# Access Compliance Report

## Public Rights-of-Way

Intersection ID: 44484	Main Street: FINN_HALL_AV	Cross Street: NEWFIELD_ST	Location: SW
ADA ID: 794B4E302BA5	Ramp Type: PerpDiag	Initial Pass/Fail: Fail	Overall Compliance: No
		Severity Score: 8.75

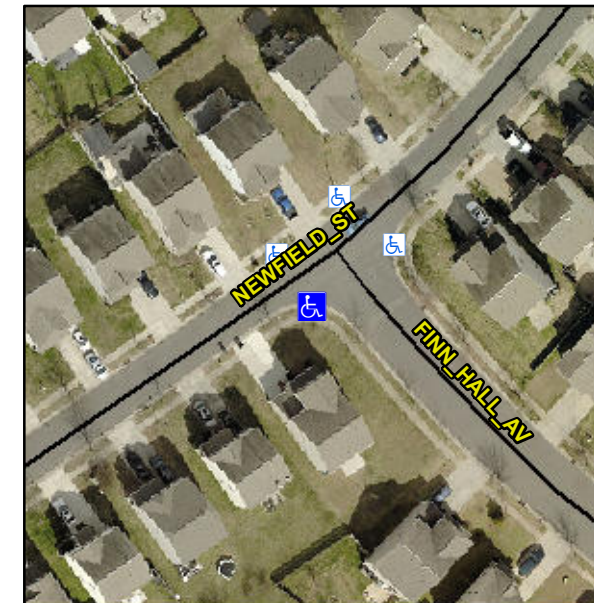
**Not Found, R304.5.1**

**Remove & Replace Curb Ramp With Two New Directional Ramps or Equivalent.**
